# ENGINEERS INSTRUCTION NO. M05

Project Name: Hyde Park Place – 248 Unley Road Apartments

Subject: Mechanical Engineers Instruction Date: 09/09/2020

**Layout Apt 1.06**

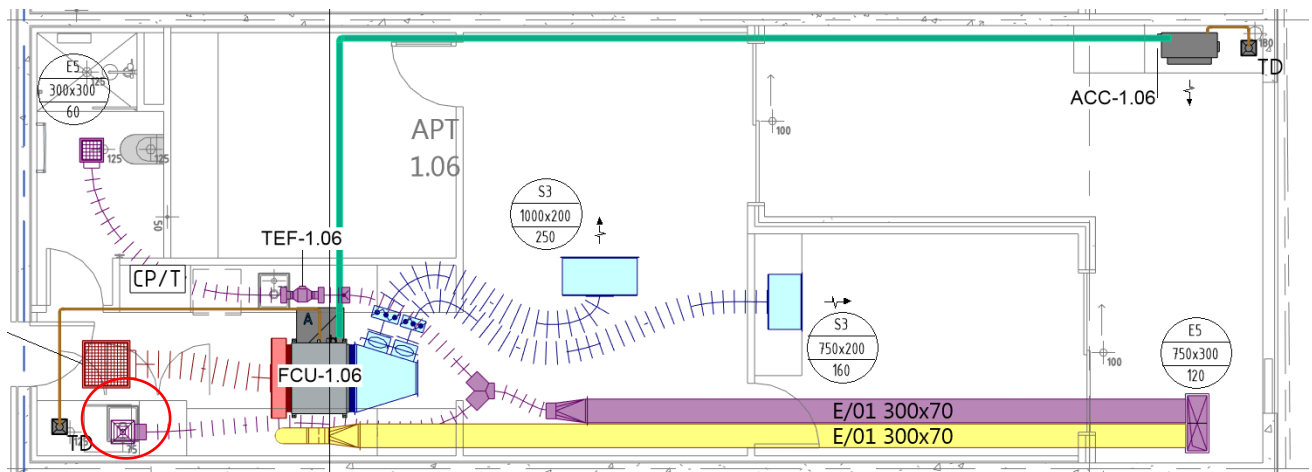
- Provide Laundry cupboards with a Header box fan (performance data below) complete with wye piece to connect to exhaust system and flexible ductwork. Layouts are provided at the end of this document. New header box fans are to be provided to the following rooms:

**Layout Apt 2.01, Apt 3.02, Apt 4.02 and Apt 5.02**

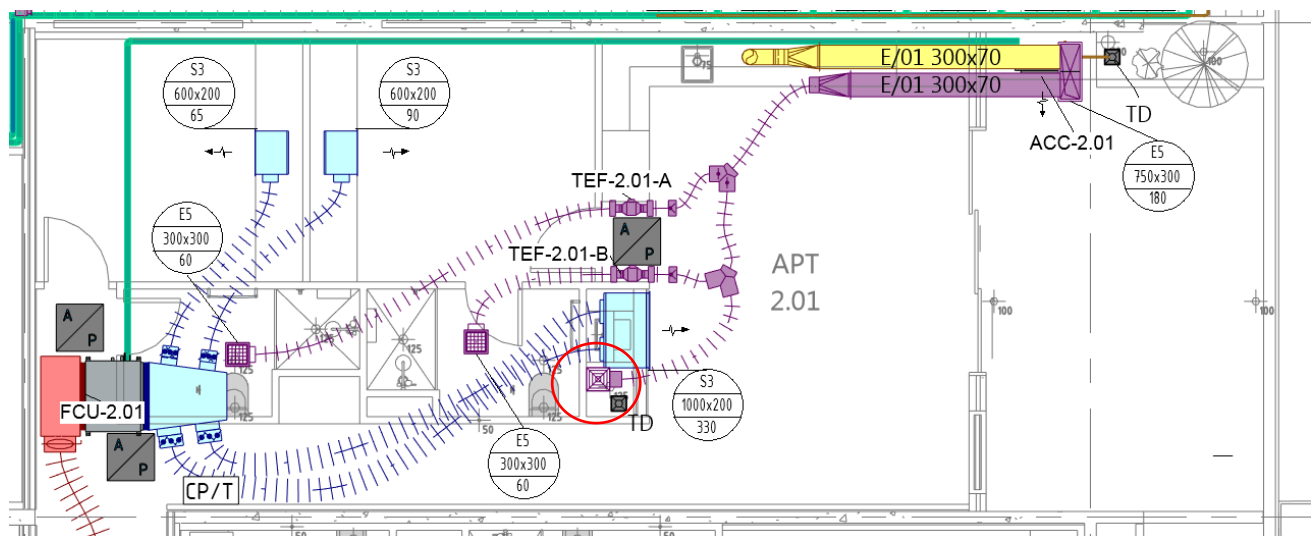
- Provide Laundry cupboards with a Header box fan (performance data below) complete with wye piece to connect to exhaust system and flexible ductwork. Layouts are provided at the end of this document. New header box fans are to be provided to the following rooms:

- Provide Laundry cupboards with a Header box fan (performance data below) complete with wye piece to connect to exhaust system and flexible ductwork. Layouts are provided at the end of this document. New header box fans are to be provided to the following rooms:

- Provide Laundry cupboards with a Header box fan (performance data below) complete with wye piece to connect to exhaust system and flexible ductwork. Layouts are provided at the end of this document. New header box fans are to be provided to the following rooms:

**Layout Apt 2.05 Apt 2.07, Apt 3.06, Apt 3.08, Apt 4.06, Apt 4.08, Apt 5.06 and Apt.508**

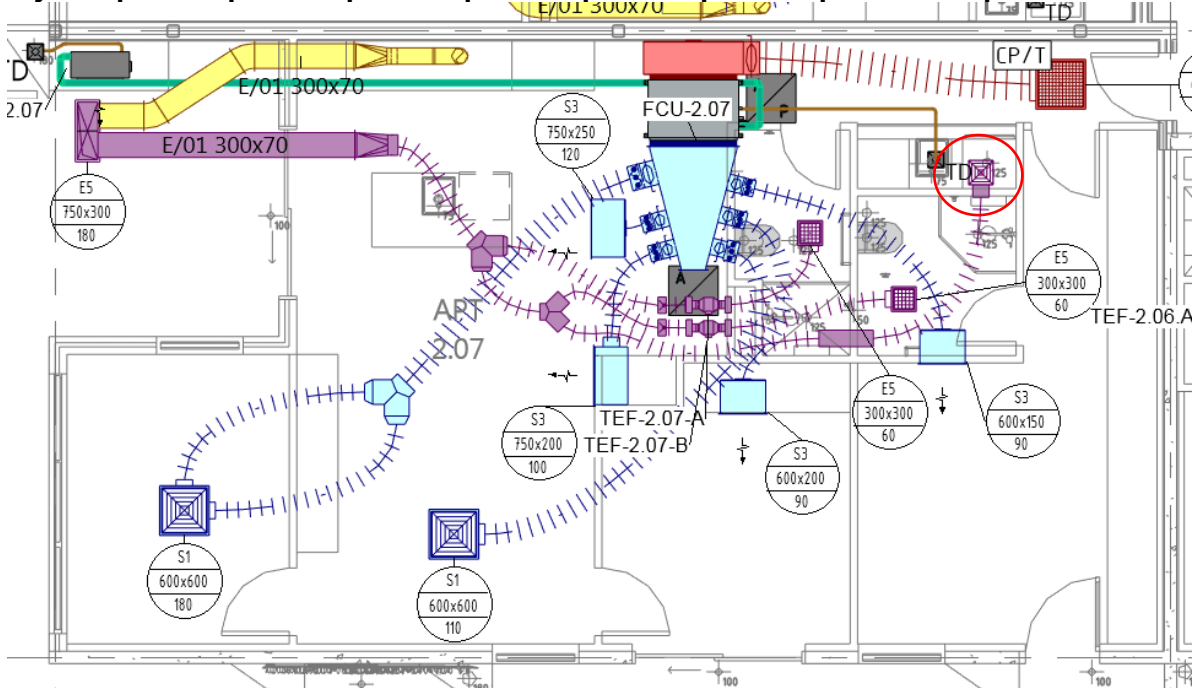
- Provide Laundry cupboards with a Header box fan (performance data below) complete with wye piece to connect to exhaust system and flexible ductwork. Layouts are provided at the end of this document. New header box fans are to be provided to the following rooms:
